Parliamentary Standing Committee on Public Works

DEVELOPMENT OF TERMINAL AREA, TOWNSVILLE AIRPORT

(Third Report of 1985)

**Floor Plan
Option 2**

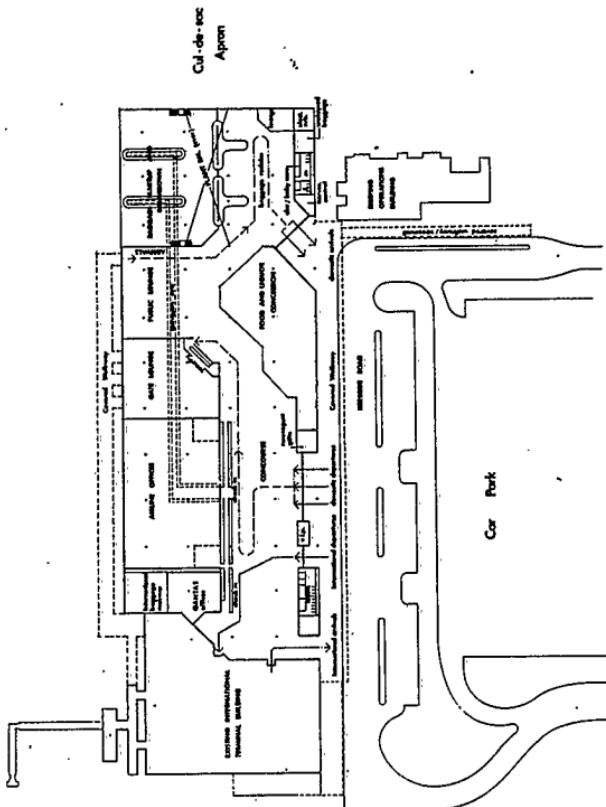
60. Option 2 Aviation presented revised plans of the original proposal at the public hearing held in Brisbane in April 1985. The revised plan, (illustrated at Plan C-4) called Option 2 for convenience attempts to overcome much of the criticism of the original proposal but retaining the same building envelope and access route. Significant changes are as follows:

- the passenger arrivals area has been relocated towards the centre of the building reducing the hazards from baggage vehicles to passengers moving along the air-side walkway;

- the baggage make-up and break-down area has been increased in size, following validation trials at Brisbane Airport, and is now located at the northern corner of the building, taking in what was previously planned as the passenger arrival entrance;

- passenger entrances and exits on the landside have been separated to more evenly distribute traffic along the terminal front to reduce the possibility of congestion in the set-down and pick-up area. This separation has been achieved by relocating the concessions area and domestic departure lounge to a more central area;

- space allocated for concessions has been reduced by 200 square metres;
- since the October 1984 public hearing Air Queensland has become associated with TAA and East West Airlines has applied for accommodation in the terminal and the two airlines can be accommodated without difficulty;

- relocation of the public lounge area, formerly adjacent to the international check-in counter and domestic gate lounge area to a more centrally located position.

(C-5)

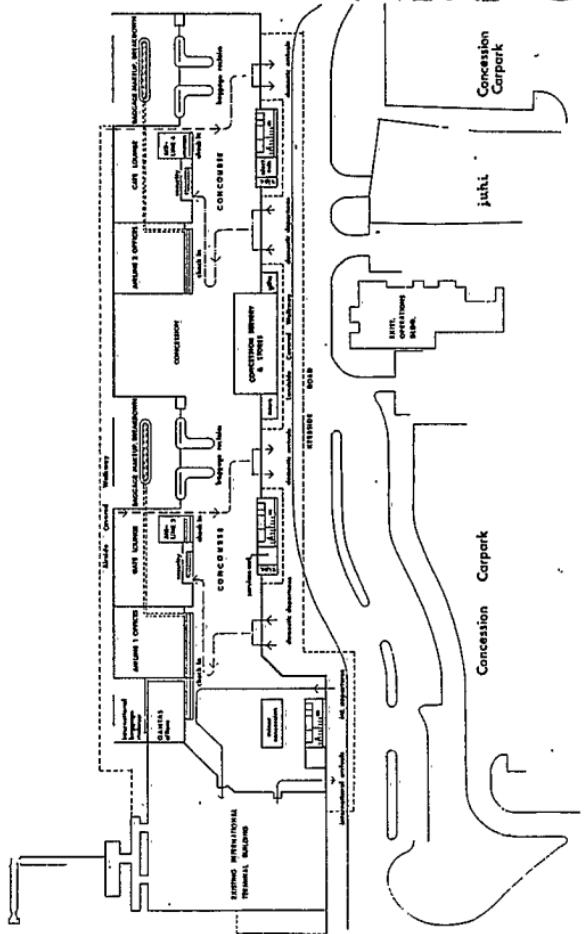
62. Option 3. Joint User Terminal The design of a joint user terminal requested from Aviation was presented at the April 1985 public hearing and is illustrated in Plan C-5. It is not supported by departments and was provided in response to the request. The design provides a narrower, more elongated building which extends across the cul de sac apron with consequent impacts

on apron space, but it permits road access along the entire land-side front of the terminal without the need for vehicles to make a sharp right-hand turn in the area of maximum vehicle concentration during peak periods. The access road would be routed between the Aviation operations building and JUHI and the narrower but longer terminal building.

(C-6)

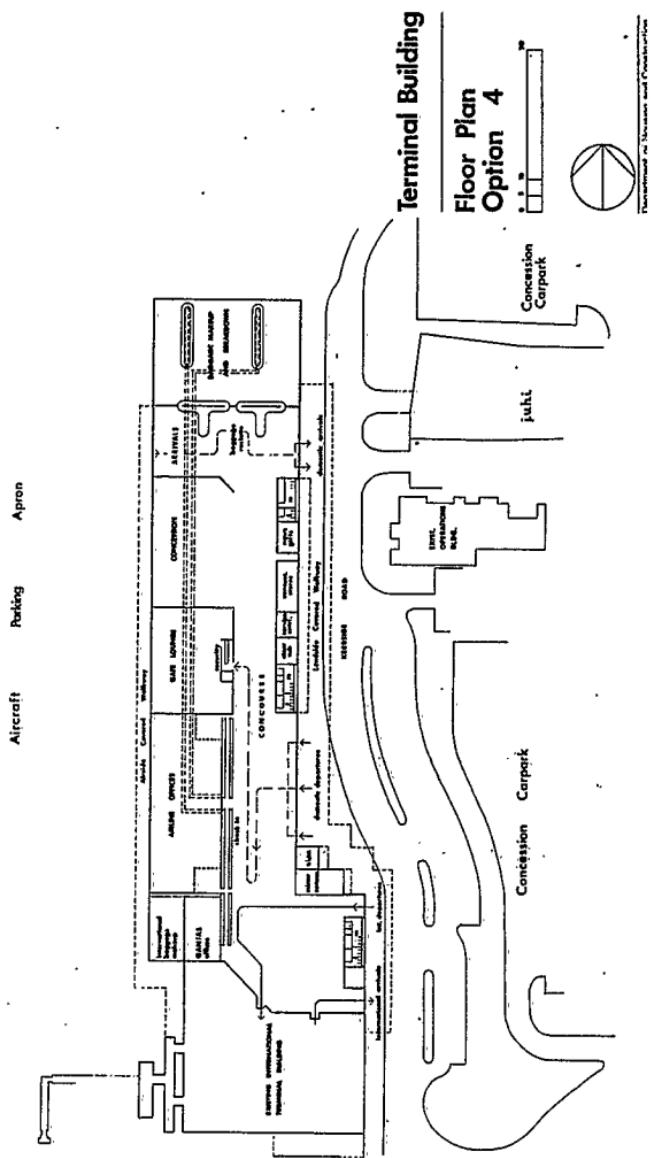
63. Option 4, Common User Terminal The Option 4 terminal plan, illustrated at Plan C-6, is a common user variant of Option 3, with the internal arrangement of functional areas in keeping with common user principles. It is not supported by Departments.

83. Option 4 is also a compromise. Whilst overcoming the access problems, its narrower lateral dimensions would restrict circulation areas more than is considered desirable. Nevertheless, the Committee believes there are advantages in adopting Option 4 as a basis for further planning because it has the following advantages:

90. The Committee notes that an observation area is not provided under Option 4. Congestion in the arrivals area and the public concourse area adjacent to the check-in and gate lounge area may arise during peak periods. It is therefore recommended that an observation deck be provided on the roof of the terminal to reduce potential congestion and to provide for later expansion of public areas.
